ADNOC GAS HABSHAN & BAB CONTROL SYSTEMS UPGRADE (PACKAGE 1) PROJECT NO. 0405323						  				
			COMMENTS RESOLUTION SHEET										
Document Title:			PIPING & INSTRUMENTATION DIAGRAM 13-C-101A TURBINE DRIVE & AUX. - TRAIN 2 EARLY THAMMAMA 'B' (HABSHAN)				AGP Response Code			Prepared By:	VK		
Document No:			13-00-210		Revision No:	B	1. Revise and Re-submit		3. Approved		Checked By:	DV	
AG Ref. No:			ADNOCGP-WTRAN-002750		Date:	11-Feb-2024	2. Approved with comments	✓	4. For Information only		Approved By:	YVR	
SN	Reference		COMPANY Comments				CONSULTANT Response			COMPANY Resolution			
	Page No.	Clause No.											
1	1	Process Comment	Why HOLD? This HOLD point is not justified.				Noted. Note 14 is updated and hold is deleted from P&ID.						
2	1	Process Comment	Why straight length requirement could not be specified for Orifice Flow Element? Why awaiting vendor info? BTME to clarify.				Noted and straight length is updated.

NOTICE: THIS DRAWING AND THE INFORMATION IT CONTAINS IS THE SOLE PROPERTY OF ABU DHABI GAS INDUSTRIES LTD. IT SHALL NOT BE REPRODUCED OR LEFT WITHOUT THE AGREEMENT OF THE OWNER.					
شركة أبوظبي لصناعات الغاز المحدودة ABU DHABI GAS INDUSTRIES LTD HABSHAN COMPLE

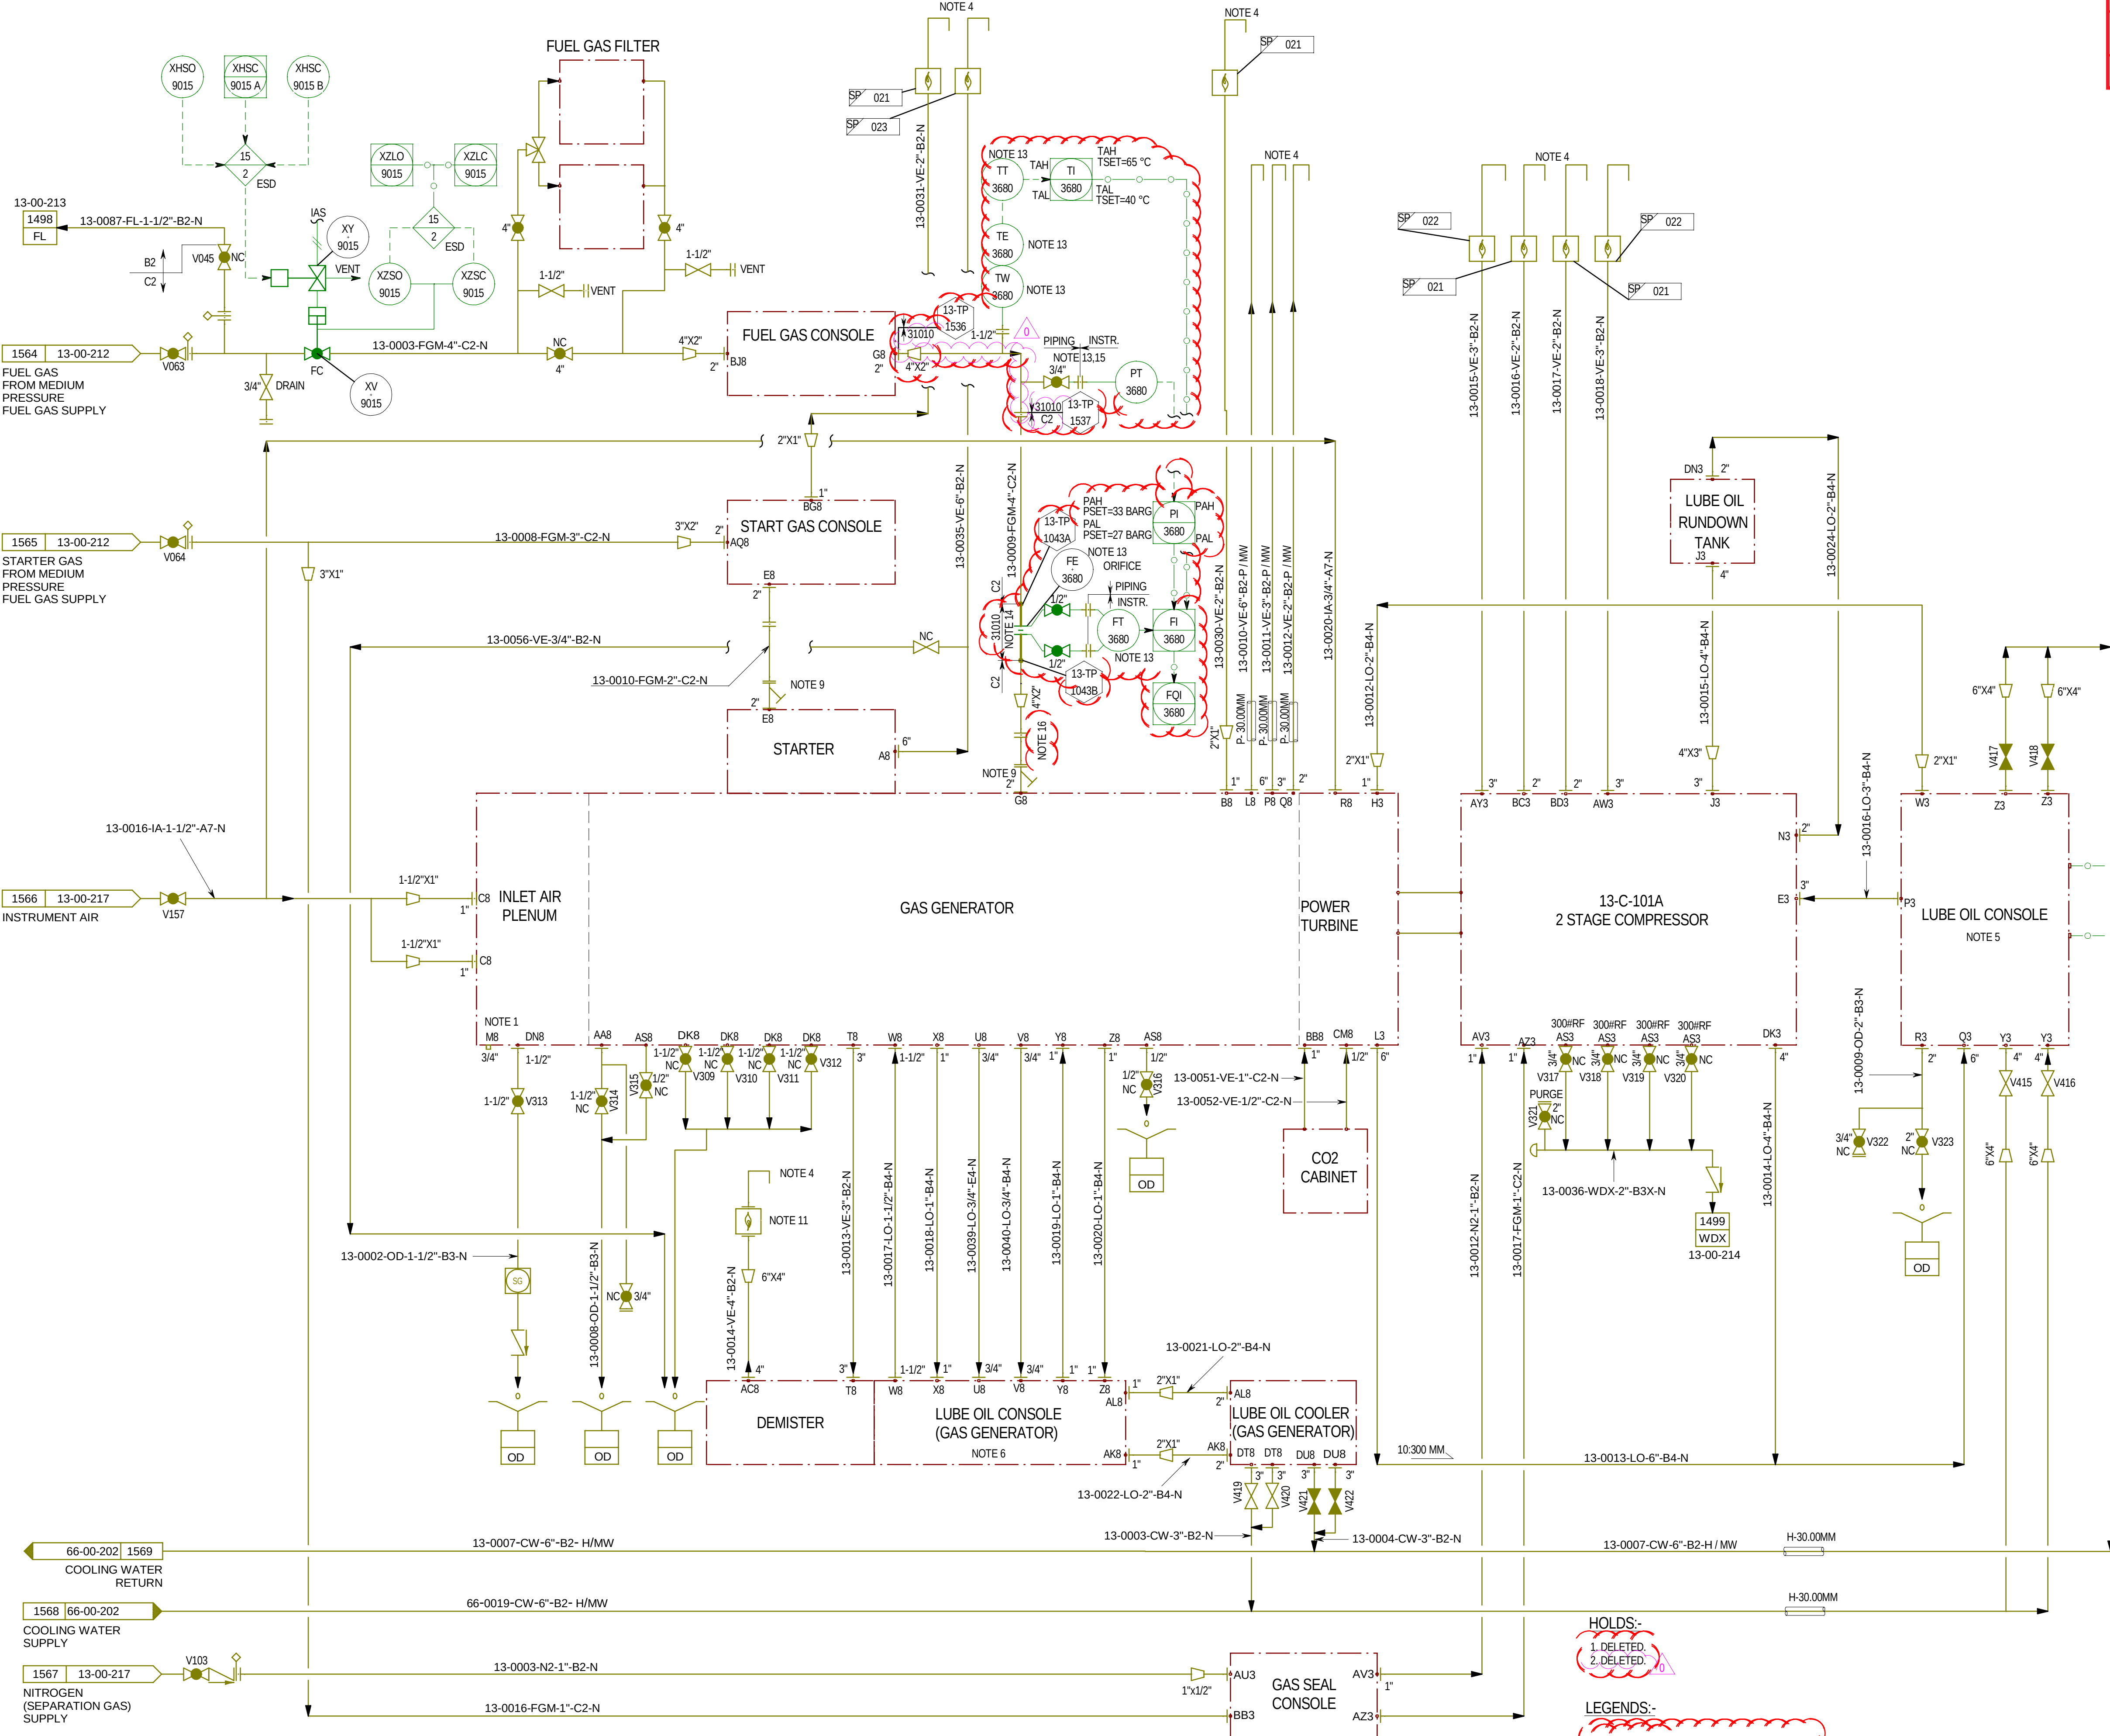
3	1	Process Comment	Please refer to general comments provided in unit.no 013 (Doc.no. 13-00-209) - 5323P1-TL-1395.				Noted and all the relevant comments are updated in the P&ID.						
4	1	-	-				Following changes are made in P&ID w.r.t. Rev.B submission as per piping/instrumentation inputs. 1. Tie-in Point 13-TP-1536 & 1537 location is updated as per piping input. 2. Note 17 added.
